Re: Warehouse Addition, 120 Morningside Dr. SE
Grading and Drainage Plan
Engineer's Stamp dated 9-7-06 (K17/D87)

Re: Warehouse Addition Grading Plan Certification
120 Morningside Dr. SE
Engineer Cert Stamp dated 9-21-09 (K17/D87)

**RE: WAREHOUSE ADDITION, 120 MORNINGSIDE DR. S.E.
(K17-D87)**

Re: Warehouse Addition, 120 Morningside Dr. SE
Grading and Drainage Plan
Engineer's Stamp dated 8-15-06 (K17/D87)

CITY OF ALBUQUERQUE

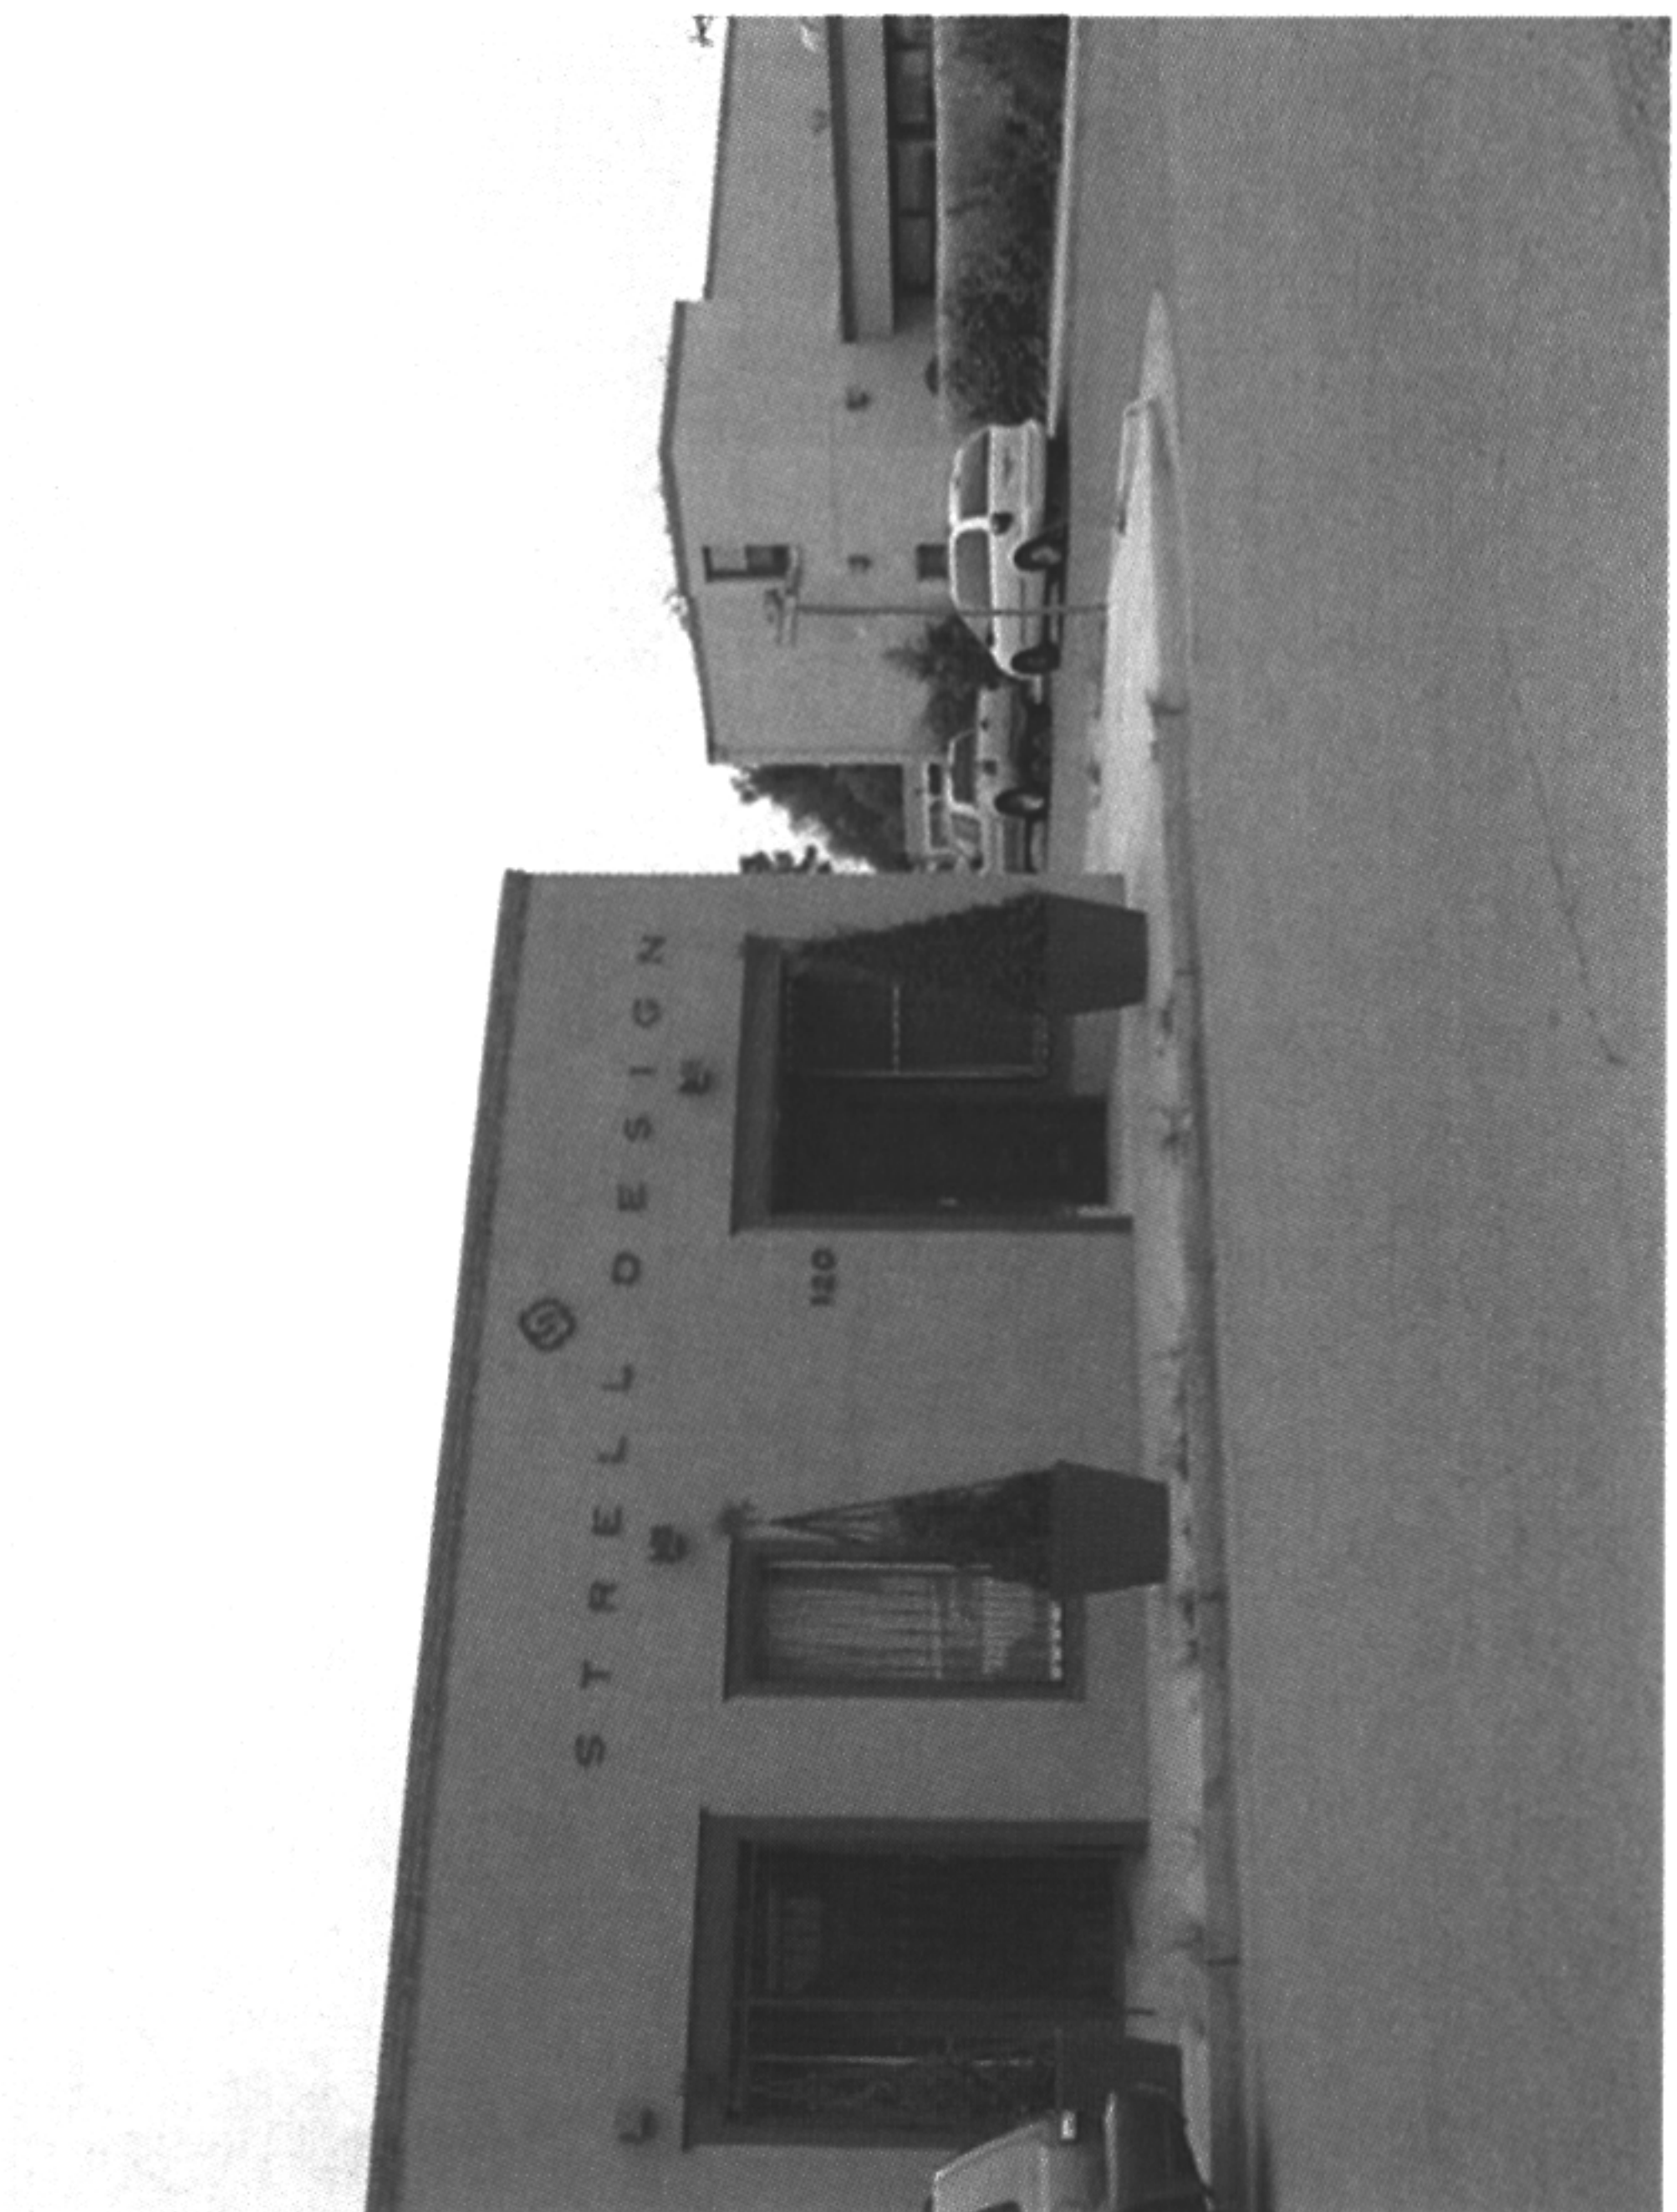
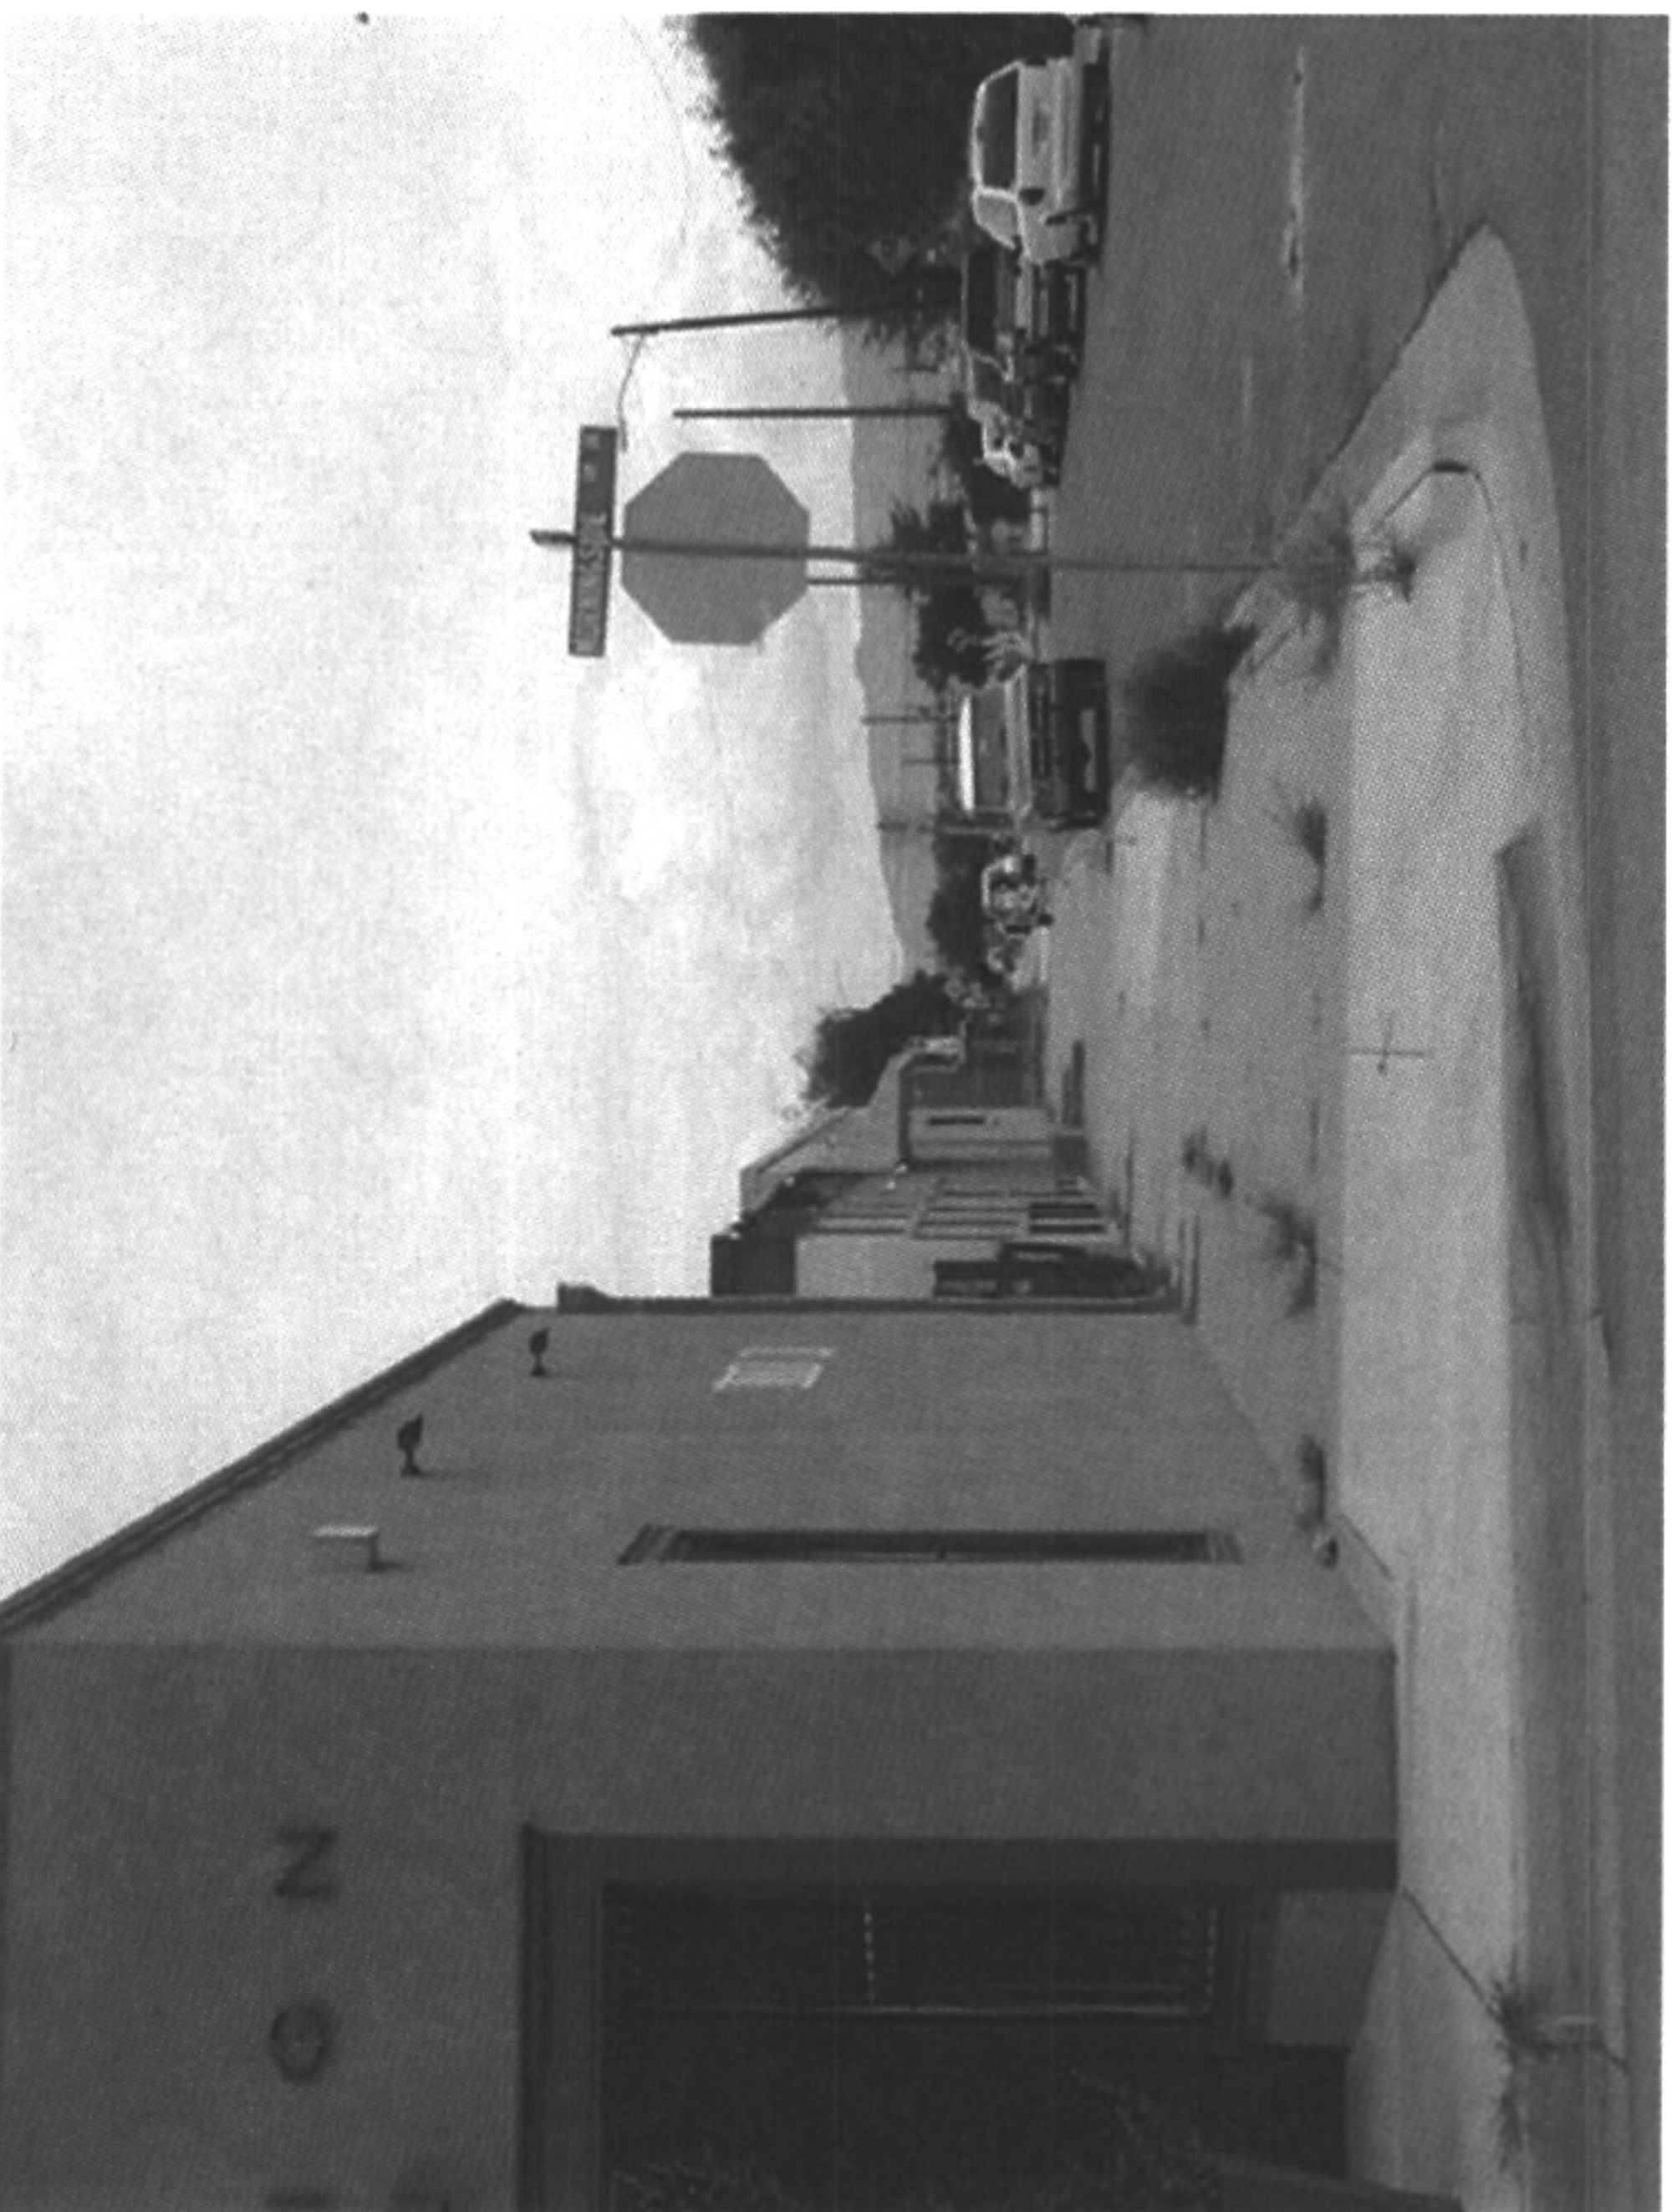
- The rundown in NE corner of the plaza was shown as deleted and this rundown is an integral feature of the drainage plan; it was needed to convey water away from the building. It is likely that water will pond adjacent to the addition and could cause issues with the foundation. If your client and the adjacent owner acknowledges this fact and will do so in writing, it could be allowed.

- Do any offsite flows enter this site? Provide existing spot elevations or contours for this site as well as the lot north of this site.
- Since the drivepad on Silver Ave. is no longer being used, it will have to be removed and new sidewalk and curb and gutter constructed. Drainage from the site will then be conveyed to Silver Ave. through a sidewalk culvert.
- How deep is the 12" concrete trough? Provide inverts for both ends.

~~Comments:~~ CURTIS, REVIEW AND SEE IF YOU CONCUR. I RAISED THE INVERTS AND I AM STILL BELOW THE FINISH FLOOR

1. Do any off-site flows enter the site? *No off-site flows enter the site from any direction. Note has been placed on the plan drawing.* Provide existing spot elevations or contours for this site as well as the lot north of the site. *Additional spot elevations have been inserted on the plan drawing for both the site and north of the site.*

2. Since the drivepad on Silver Ave. is no longer being used, it will have to be removed and new sidewalk and curb and gutter constructed. Drainage from the site will then be conveyed to Silver Ave. through a sidewalk culvert. *Two parking spaces have been designed to be located just south of the proposed building. A concrete trough will drain the roof run-off onto the new proposed asphalt within the parking spots. From that point it will drain out the existing drivepad. The existing drivepad will be utilized.*

3. How deep is the 12" concrete trough? *The proposed concrete trough will be 12" wide by 6" deep.* Provide inverts for both ends. *Inverts have been provided on the plan drawing for each end.*
